August 23, 2001

SUBJECT: TECHNICAL ASSISTANCE REQUEST - REVIEW OF GROUNDWATER
TEST RESULTS SUBMITTED BY VIRGINIA POWER CO. FOR ITS
CATEGORY I SERVICE WATER POND DAM AT NORTH ANNA

Project: Dam Safety Inspection - North Anna Category I Service Water Pond Geochemistry

FIGURE 1
PLAN-CURRENT INSTRUMENTATION
SERVICE WATER RESERVOIR
NORTH ANNA POWER STATION

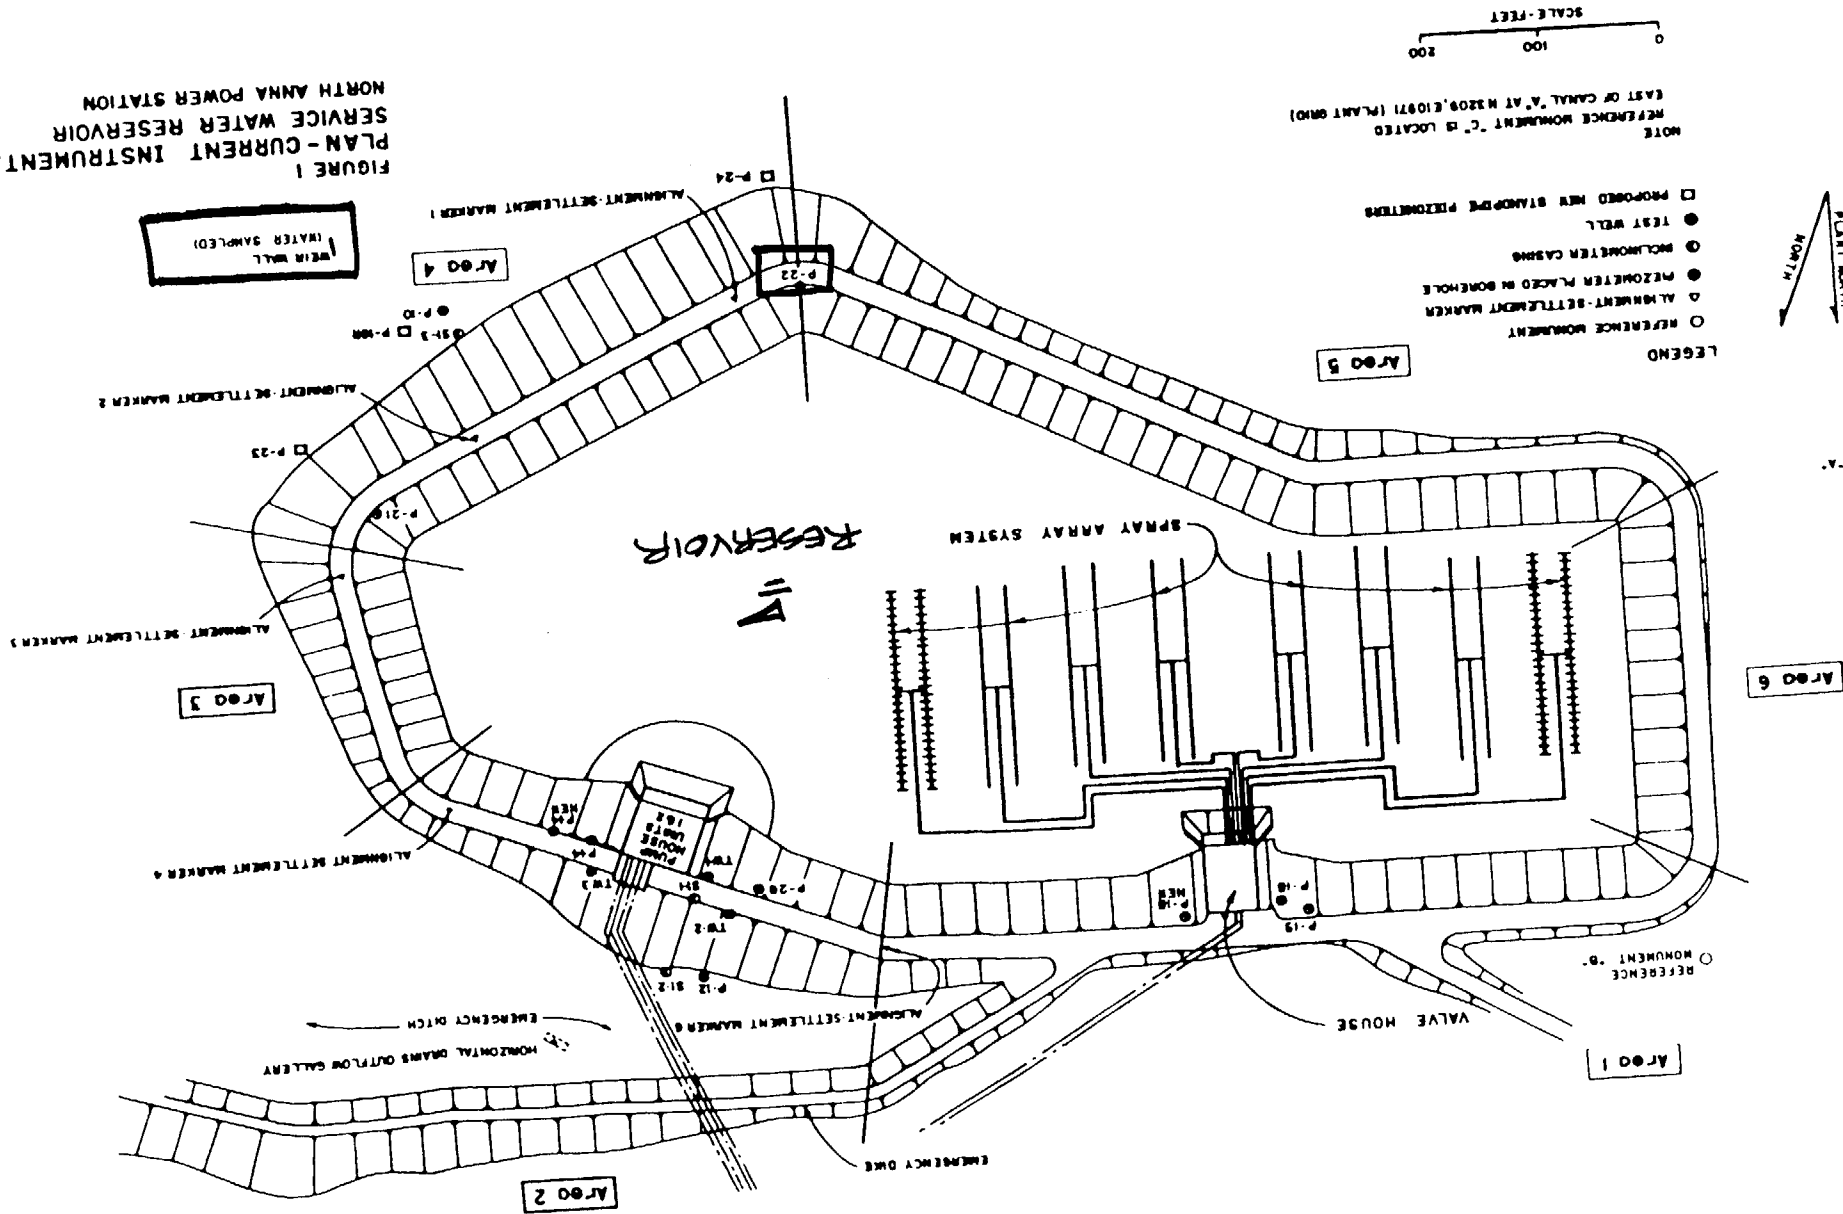
Requested Action: Reviewer shall determine if information submitted by Virginia Power Co. (VPC) is sufficient to determine if impounded water can be related chemically to water from piezometer P-22 and/or surface water from a wet area below the SWR dike. If licensee-provided information is insufficient, reviewer shall provide written recommendations for appropriate testing to make such determination. If the information provided is sufficient, then reviewer shall make a written opinion regarding any relationship of the water from the three sources.

Background: In 1997, 1999, and 2001, NRC has observed apparent seepage water below the SWR embankment. VPC has stated that the water is runoff, unrelated to seepage. On January 12, 1998, VPC took water samples from the SWR, piezometer P-22, and ponded water below the SWR dike. VPC ran conductivity tests and concluded that the water from P-22 and below the SWR dike did not originate from the reservoir. A technical review of the test results and conclusions is requested.

4. Virginia Power Corporate staff indicated that analysis of seepage water could determine whether seepage was from the SWR. Once the weirs are operational, water samples should be taken to see if the water source is in fact the SWR.

5. Reactivate weirs for flow measurements. Those that cannot be made functional should be removed and new weirs established.

Action: Water samples were taken from three areas around the SWR on January 12, 1998 to measure conductivity. These included water from the service water reservoir, water from piezometer P-22 casing during bailing, and ponded water at the weir wall in the wet area below the SWR dike and adjacent roadway (Attachment 2, Figure 1).

Piezometer P-22	99 micromhos
Weir Wall	123 micromhos
Service Water Reservoir	922 micromhos

Conductivity is a measure of a solutions capacity to conduct electric current and depends on the presence of ions. The more dissolved salts/ions that are present in the solution the higher the conductivity that would be expected. The substantially higher conductivity values obtained from the SWR sample is due to the biocidal and other chemical treatment used in the reservoir.

These conductivity tests clearly indicate the water obtained from piezometer P-22 and the drainage area did not originate from the reservoir and therefore are not the result of seepage from the reservoir. As a comparison, the conductivity of distilled (de-ionized) water ranges from 0.05 to 2.0 micromhos.

Action: Results of the conductivity tests on a water sample taken from the weir wall which is located downstream or downgradient from the other weirs, clearly indicates that the water did not emanate from the reservoir. Therefore, reactivating weir flow measurements would only measure runoff and groundwater movement which would provide extraneous data not pertaining to SWR seepage or stability. In our opinion, such effort is unwarranted.
